Re: Re-zoning and Development Permit Application: 1400 Fairfield Road and 349/351 Kipling Street
(Rez No. 00702 & DP No. 000555)

Appendix A: Summary of Plan Revisions – Direct Responses to the Committee of the Whole Meeting (February 11, 2021)

Appendix B: Responses to Advisory Design Panel (ADP) motion to approve with changes (August 26, 2020)

Top: Presented to COTW Feb. 11, 2021

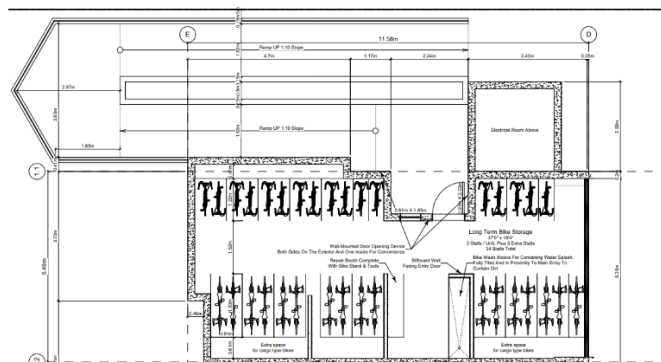
<p>Motion 5: ensure the form and character of the development is compatible with the predominant neighbourhood character, consistent with the Design Guidelines for Development Permit Area 15F: Intensive Residential – Attached Dwellings”</p>	<p>Several actions have been taken to ensure form and character compatibility. The revised submission now includes the following design elements:</p> <ul style="list-style-type: none"> ● Traditional architectural features such as a chimney, wood soffits, and peaked rooflines; ● Bay windows and “punch” traditional windows; ● Traditional cladding, which includes wood soffits, vertical wood siding, and wood shingles; ● Front Porches on Fairfield Rd. and Thurlow Rd. Facades; ● Reduced hardscape through clustered parking; ● Landscaped front and rear yards; ● Limited upper level rear windows to reduce overlook; ● A single-family house looking façade along Thurlow Rd., which is currently comprised of primarily single-family homes. <p>See below a side by side comparison between past versions illustrating the change in form and character:</p>

Bottom: NEW Revised resubmission May 2022.

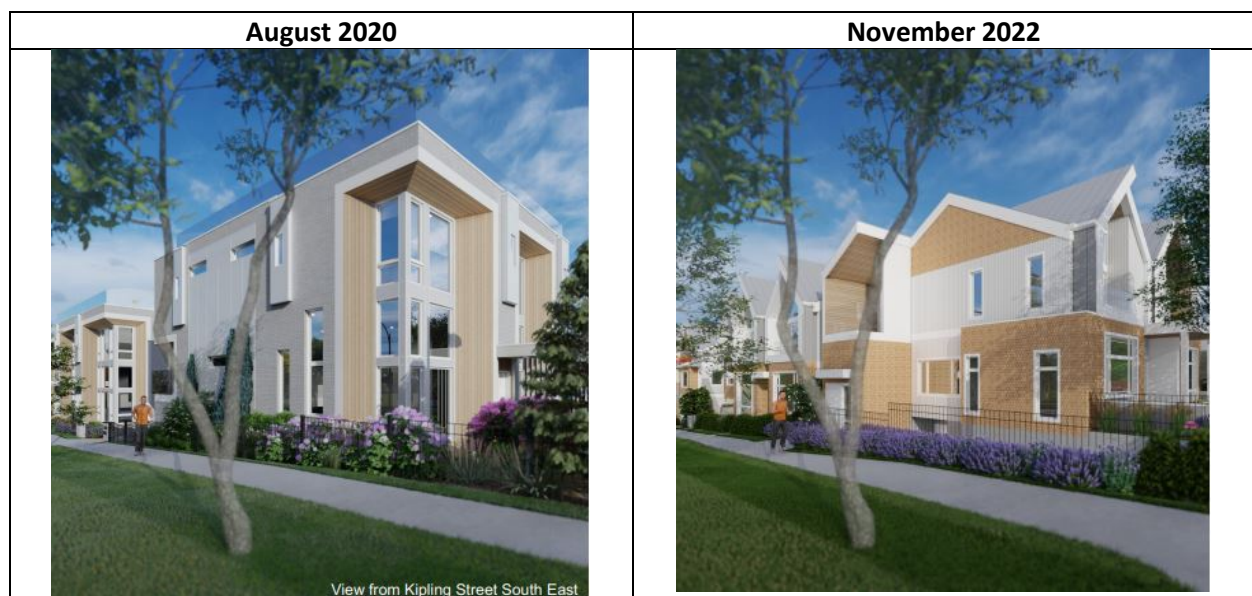
ADP MOTION: Address the Kipling Street elevation of building two and the Thurlow Street elevation of building one.

ADP MOTION: Consider improvements to privacy screening of building two at the rooftop level.

ADP MOTION: Consider alternative narrower species of planting along the drive aisle.

ADP MOTION: Evaluate increasing the access to light into lock off suites.

ADP MOTION: Improve the transparency of landscaping on Thurlow Street.

Actions Taken: The following revisions were made to the Kipling Street elevation, referenced by the ADP:

- The setback from the street and sidewalk was increased.
- An at grade electrical room (at grade) was added to meet BC Hydro site servicing requirements, with a covered balcony added above the electrical room (fronting Kipling Street/Robert J. Porter Park).
- A shared bicycle room was added below Unit #8, with a bicycle ramp to access the space from Kipling Street.
- Exterior materials were revised from hardie panels and Brick to wood shingles and vertical siding to increase consistency with neighbourhood form and character.
- Rooftop decks were removed, and pitched roof forms were added to increase alignment with form and character of the area.

The following revisions were made to the Thurlow Rd. elevation referenced by the ADP:

- The rear drive aisle was removed, with six parking garages placed at the centre of the consolidated lots with access from Kipling Street and two parking garages located with access from Thurlow Rd. Private rear yards were added to seven of the nine units, where the drive aisle was previously located. While the two units fronting Fairfield Rd. do not have private rear yards, they have landscaped front yards, and patios on the main floor and second floor.

- Unit #1, which fronts onto Thurlow Rd. was re-designed to present the street (Thurlow Rd. frontage) as a single family dwelling which is consistent with the predominant housing form on Thurlow Rd.

- Exterior materials were revised from hardie panels and Brick to wood shingles and vertical siding to increase consistency with neighbourhood form and character.

- Rooftop decks were removed, and pitched roof forms were added to increase alignment with form and character of the area.

Actions Taken: Rooftop decks were removed from the plans due to concerns related to form and character and overlook. Rear at grade rear yards added to seven of the nine units, and street facing balconies on all units.

Actions Taken: This portion of the motion related to concerns related the general usability of the drive aisle. The rear drive aisle was subsequently removed, with six parking garages re-located at the centre of the consolidated lots with access from Kipling Street and, two parking garages located with access from Thurlow Rd. Private rear yards were added to seven of the nine units, where the drive aisle was previously located. This allowed for four trees to be planted at the rear of the site for screening.

Applicant Response: Lock off suites were removed from the proposal. The number of units was revised from 8 townhouses with two lock-off suites (10 units), to 9 townhouses. All 9 townhouses are located at or above grade, and have direct access from the street.

Applicant Response: All fencing along the exterior of the yard was removed, a number of shrubs along the property line were removed, and the lawn area expanded to increase transparency into the site along the Thurlow Rd. frontage.
